CITY AND COUNTY OF SAN FRANCISCO
DEPARTMENT OF CITY PLANNING

**FINAL
ENVIRONMENTAL IMPACT REPORT**

**PARK HILL
RESIDENTIAL**

PUBLICATION DATE: March 25, 1983
PUBLIC HEARING DATE: April 28, 1983
PUBLIC COMMENT PERIOD: March 25, 1983 through
April 28, 1983
CERTIFICATION DATE: June 30, 1983

FIGURE 6: Chapel Building Floor Plan (Entry Level)

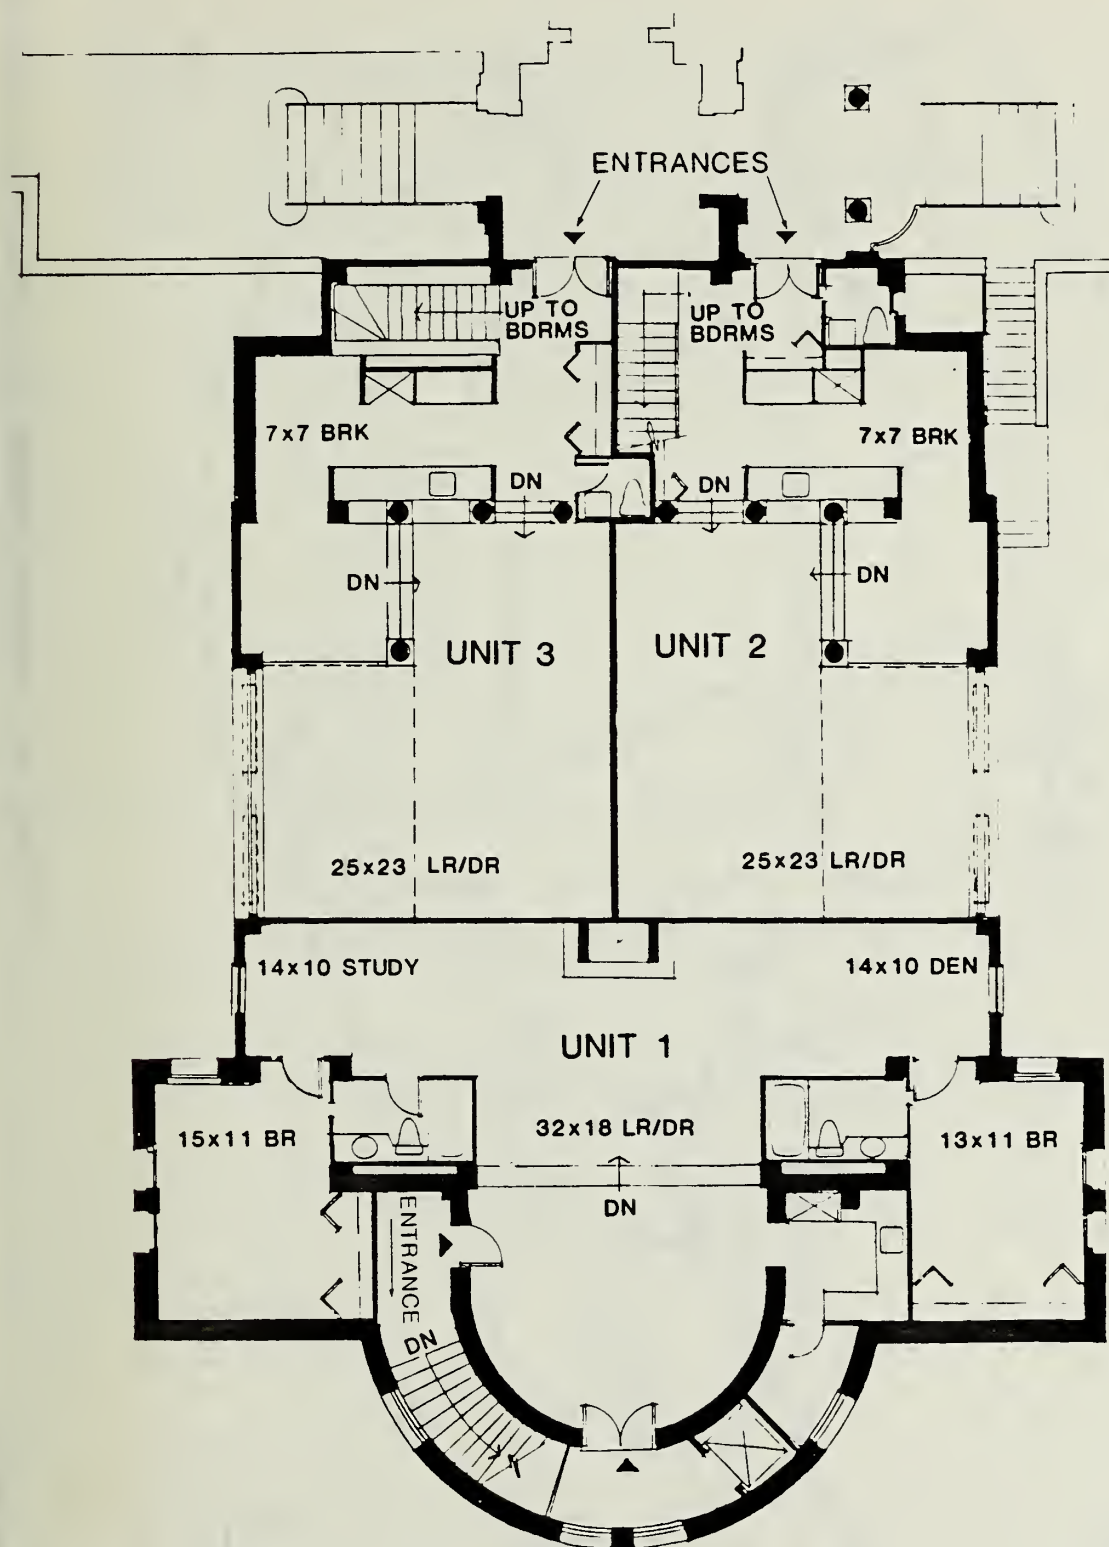
"Figure 2, page 12, the site plan is lacking substantial information. Without showing building entrances, building organization and function are unclear. Ground floor plans of the hospital, convent and new construction are conspicuously absent. Without ground floor plans, the buildings lack any relation to the site. Critical to intensive developments are door and garage security systems; nowhere in the EIR Draft are such systems mentioned. How safe, for example, will unescorted women feel in a parking garage 30 ft. below street level? What incentives/requirements will be designed to encourage residents to descend into this pit rather than park in the streets in the area." (CRD, pp. 49-50 and Michael Immel)

Figure 6, Chapel Building Floor plan on p. 16 of the Draft EIR has been revised to explain the entry to Unit 1. Because of the grade difference of the site, the resident of Unit 1 would enter from a stairway up to the dining room (see revised Figure 6a on p. 16a of this document).

The ground-floor plan of the chapel is shown in Figure 6 on p. 16 of the Draft EIR. Building entrances to the chapel are now shown in the revised Figure 6. Ground floor plans of the hospital and convent have been added to the EIR as Figures 4 and 5 (see pp. 97-98). (The existing Figures 4 and 5 have been changed to Figures 4a and 5a, respectively.) The interior design of the new construction has not as yet been completed by the project sponsor and architect. (Stephen Koch, Project Manager, Prometheus Development Company, letter communication, May 12, 1983). The conceptual ground-floor plan of a typical townhouse has been included in the EIR as Figure 6a (see p. 99). As stated in the Final Initial Study on p. 238 of the EIR, the project would incorporate internal security measures such as well-lighted entries, alarm systems, and locked entrances with security telephone. The project sponsor states that locations and specific types of door and security systems have not been decided upon. These decisions would not be made until advanced stages of project design (Stephen Koch, Project Manager, Prometheus Development Company, written communication, May 12, 1982).

FIGURE 4b: Hospital Building Floor Plan (Roof Level 6)

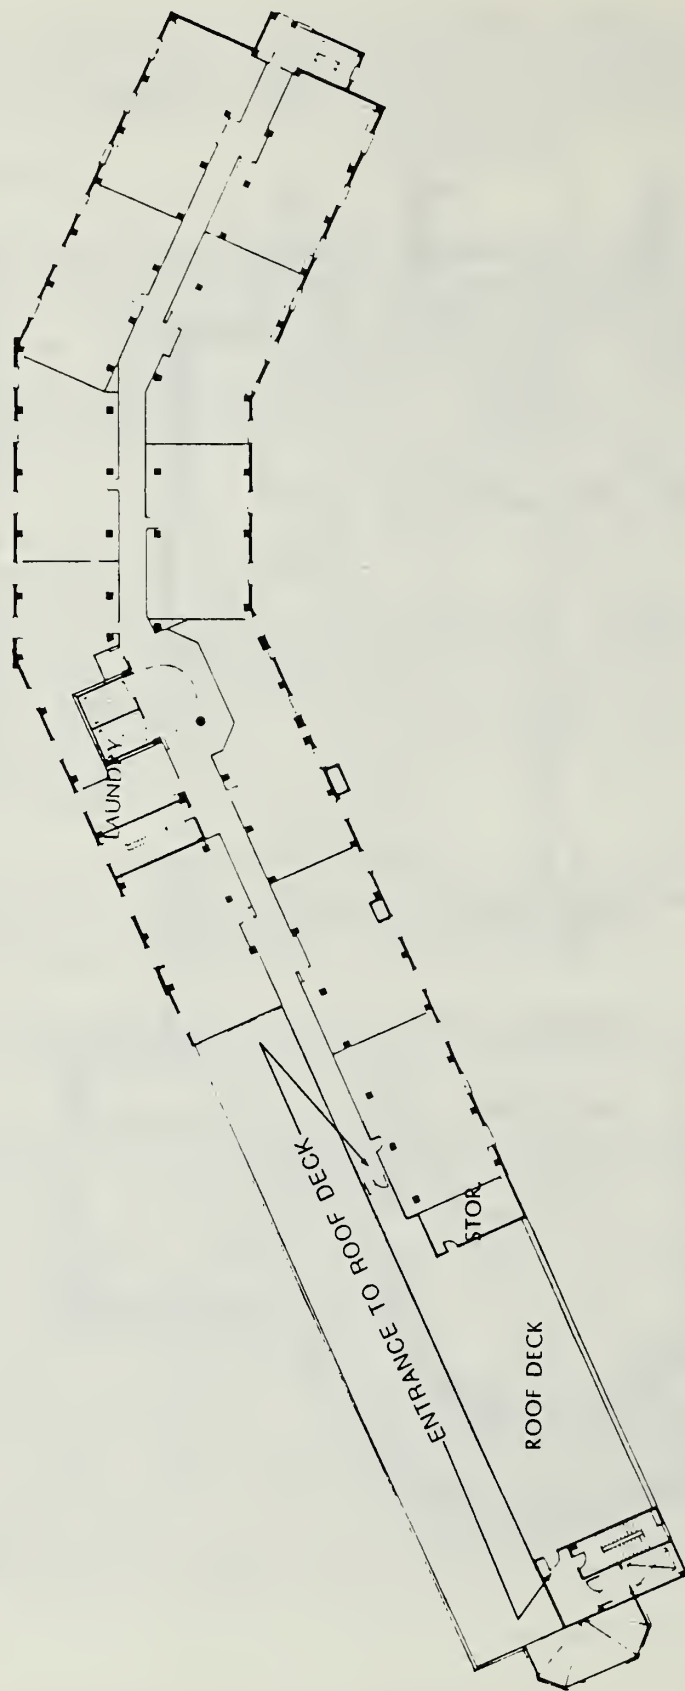
"Interior space planning: Figure 4, page 14, a typical hospital floor plan shows a long blind corridor with only one elevator location - 200 ft. from the farthest apartment. Daylighting is poor: baths typically have no windows, and some kitchens are more than 25 ft. from the nearest natural light source (Fig. 5 [a], p. 15). The chapel residential adaptation is confusing: how is entry gained from the site to unit No. 1? (Fig. 6, p. 16). The dining room in the apse is 36 ft. from the nearest window. In addition to ground floor plans, the upper 6th floor of the hospital should be shown indicating access to the sunroof." (CRD, p. 50 and Michael Immel)

The sixth floor of the hospital is shown in a new Figure 4b that will be incorporated into the Final EIR; access to the sunroof is also indicated in that figure (see p. 96).

FIGURE 8: East-West Site Section

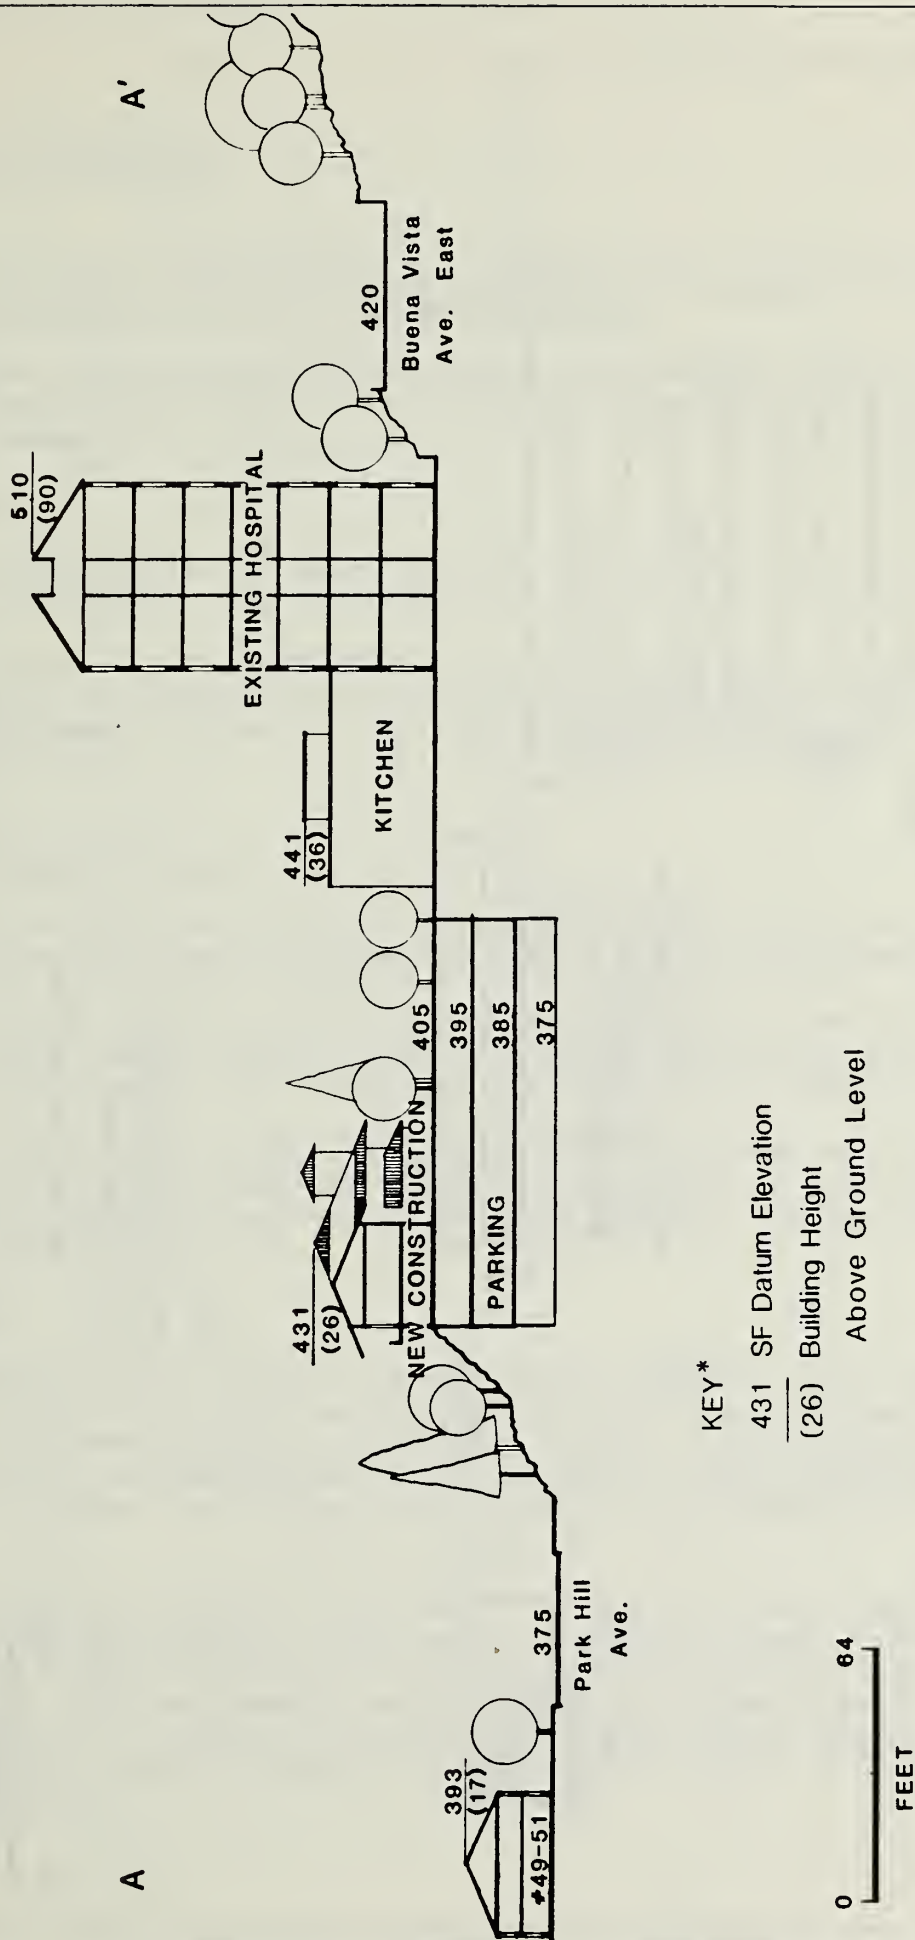
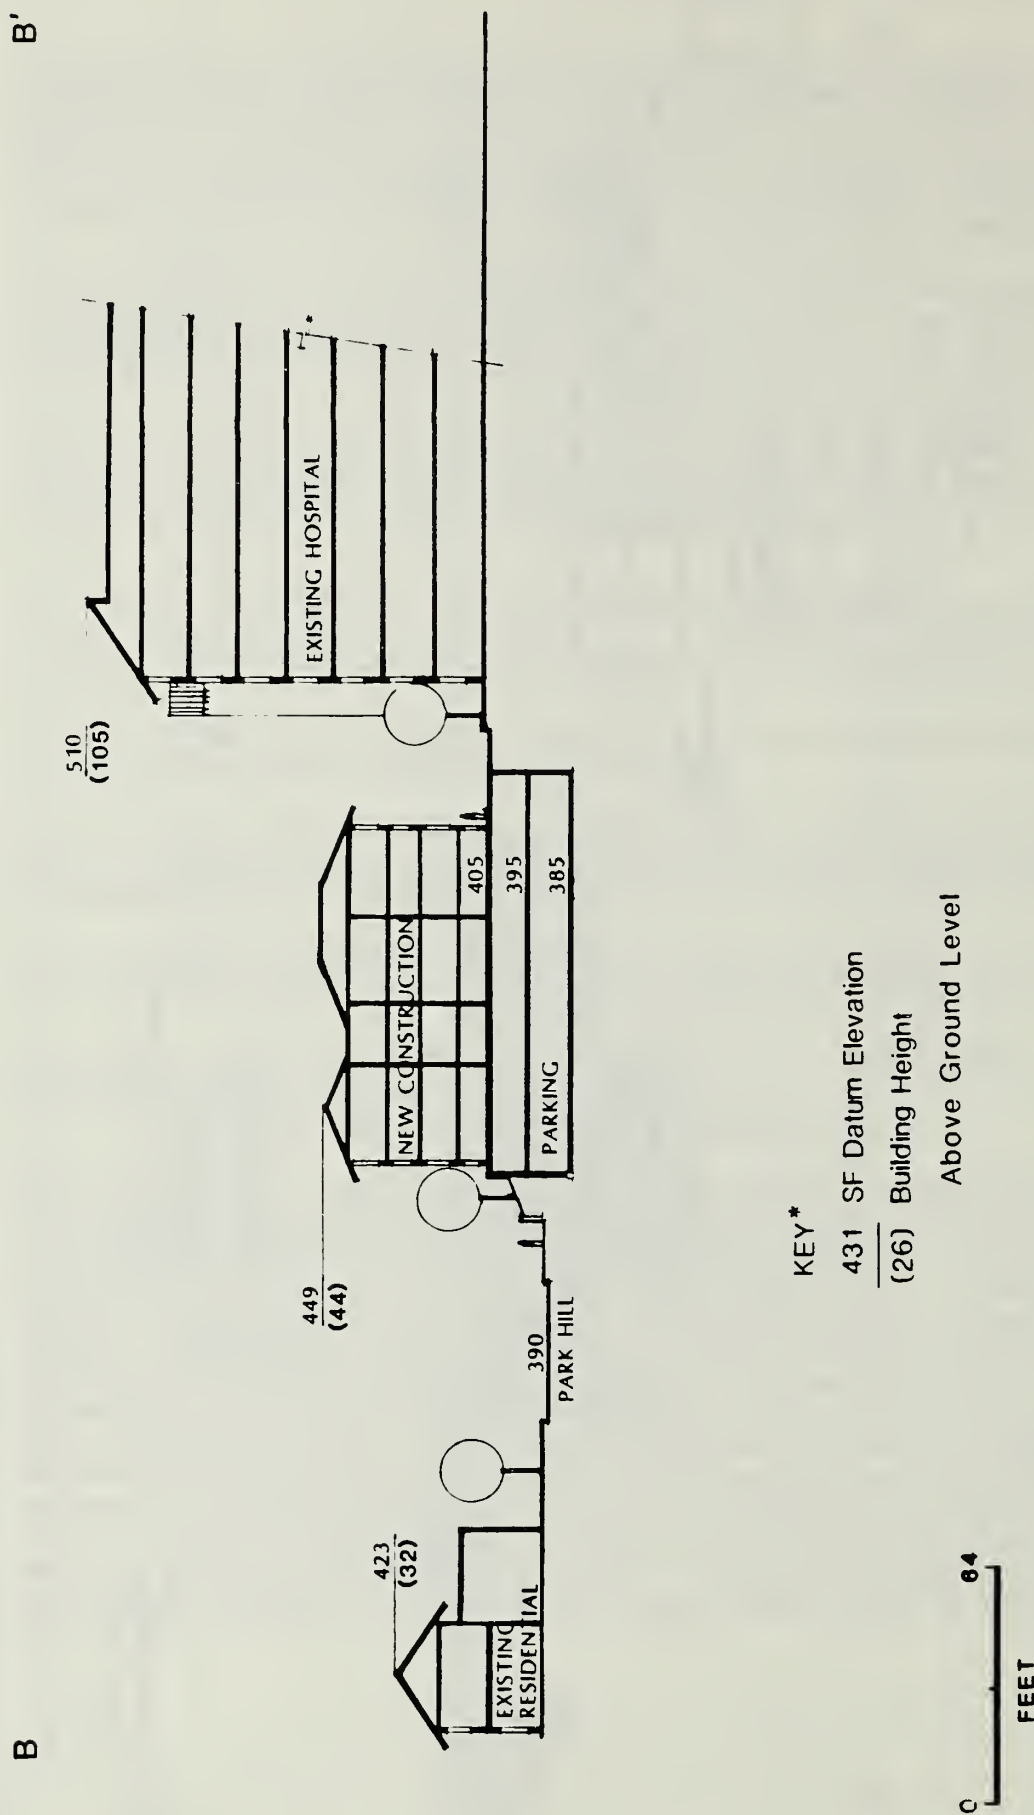
"In Fig. 8, page 19, the sponsor has shown a sectional drawing. But the section goes through only the lowest part of the new construction. The four-story new construction -- the most critical scale problem -- is not shown. It also fails to show the existing grade for comparison purposes. In Fig. 17, 17a, 18, 18a, pp. 42-54 again only the lowest new construction is depicted. These photo sketches should also be done for the Park Hill - Buena Vista East intersection where the new work is twice the size depicted in these figures." (CRD, p. 48 and Michael Immel)

The Site Section, Figure 8 has been revised to show the height of the residences at No. 49-51 Park Hill Ave. (see p. 101). The section is drawn to scale, allowing relative comparisons in scale to be made without indicating building heights.

A new Figure 8a has been added to the EIR (see p. 102). Figure 8a shows a section located at the tallest point of the four-story townhouse structures.

FIGURE 11a: Open Space and Freight and Service Access

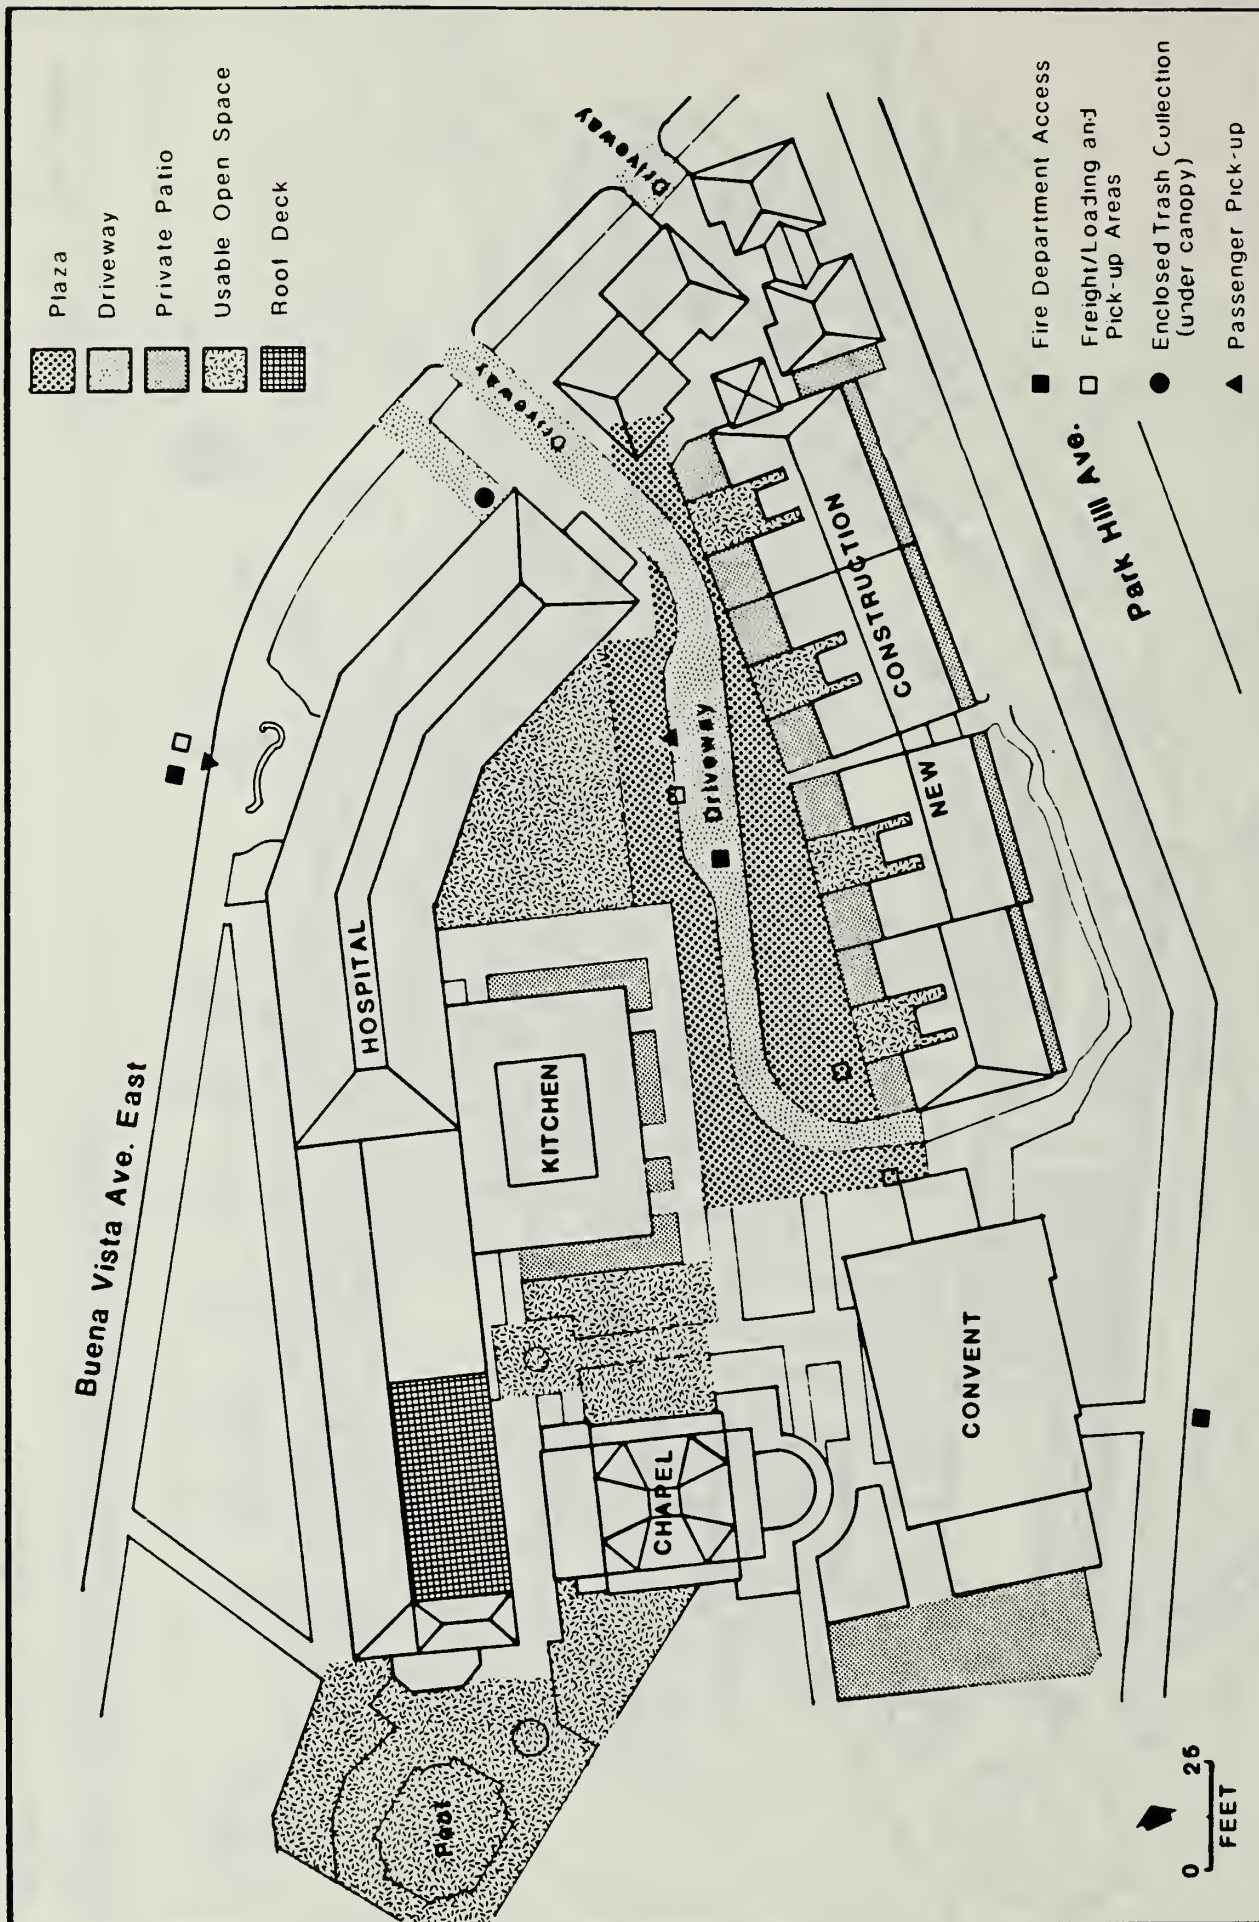
The driveway and plaza area shown on Figure 11a does not have an adequate maneuvering area or turning radius for firefighting equipment. Adequate space could be provided by using about half of the open space area located west of the interior driveway (between the hospital and kitchen block). This area could still be used for open space but could not contain structures or be landscaped in a manner that would prevent access by firefighting equipment. The Fire Department indicates that with all of the stipulations stated above, the project would provide adequate access (Edward Phipps, Assistant Chief, Support Services, San Francisco Fire Department, letter, June 2, 1983 and telephone conversation, June 17, 1983).

A site plan showing the locations of freight loading and service areas in relationship to the driveway entrances has been added to the EIR as Figure 11a (see p. 106) As stated in the second paragraph on p. 55 of the Draft EIR, no central off-street freight loading area has been designed for the site. To describe freight loading and service access, the paragraph below has been added after the third paragraph on p. 17 of the EIR.

"All loading and service access would be from Buena Vista Ave. East (see Figure 11a). Garbage collection would occur at the existing driveway at the northeast corner of the existing hospital building. The trash collection area would be located under the canopy which encloses the former emergency vehicle entrance to the hospital. Deliveries and moving of household goods would occur at the main hospital entrance on Buena Vista Ave. East or within the interior driveway."
